Groundwater Application Review Summary Form

Application # G- 19278

GW Reviewer Mitra Khadka/Travis Brown Date Review Completed: 8/9/2023

PUBLIC INTEREST REVIEW FOR GROUNDWATER APPLICATIONS

Water-Level Measurements in Nearby Wells

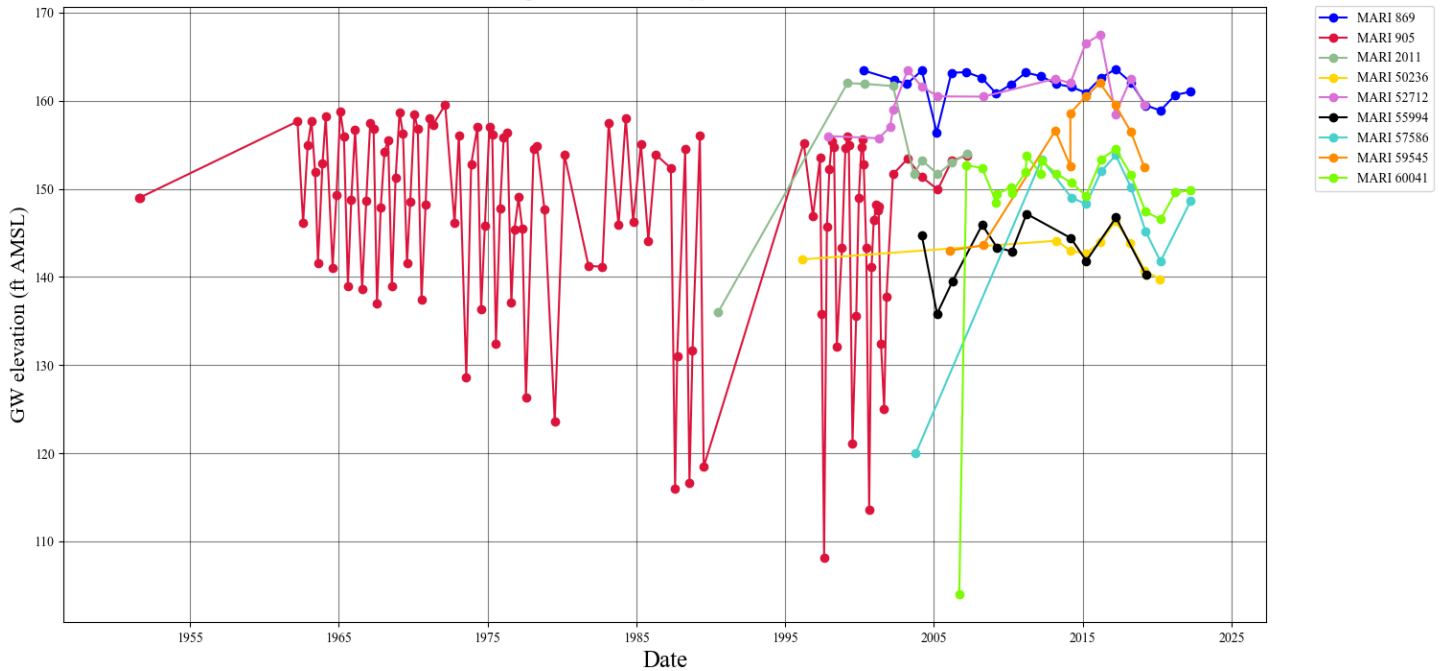
The requested pumping rate (~37 gpm) is well within the range of reported yields for water wells in this area. Median well yield is 47.5 gpm in the area (see attached Well Statistics). Static water levels are typically 20-40 ft bls in this area of the Willamette aquifer, though seasonal water level fluctuations in the shallow alluvium are typically 50-60 ft per year (see attached Hydrographs). Despite the substantial fluctuation in water level, which is expected to grow as groundwater use increases in this area, and the relatively shallow total depths of the proposed POA, the low requested rate should mean that there will be sufficient available head for the proposed use. Groundwater level data from nearby wells for last 20-25 years indicate reasonably stable groundwater conditions (see attached Hydrographs).

Well Interference Analysis

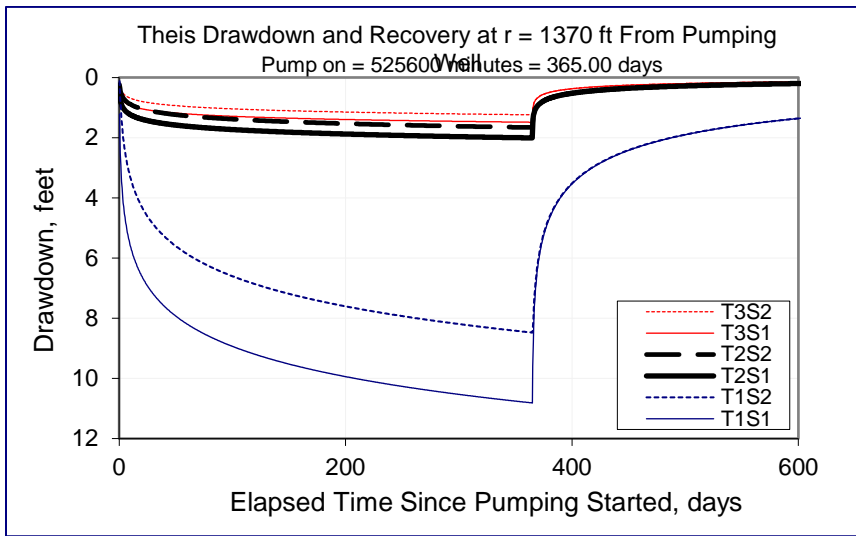
The nearest permitted well to the proposed POA appears to be MARI 837 (Registration No. GR-1352), located about 1370 ft northeast of the proposed POA PROP 342. Interference with MARI 837 was quantitatively estimated using a Theis (1935) time-drawdown model for a confined aquifer. Hydraulic parameters used for the analysis were derived from regional data and studies (Pumping Test Reports; Conlon et al., 2005; McFarland and Morgan, 1996). The analysis estimates maximum drawdown to be ~11 ft in MARI 837 after 365 days of continuous pumping at the maximum requested rate (see attached Well to Well Interference). The proposed use of groundwater is not anticipated to cause Substantial and Undue Interference with neighboring wells that meets a definition of well-to-well injury.
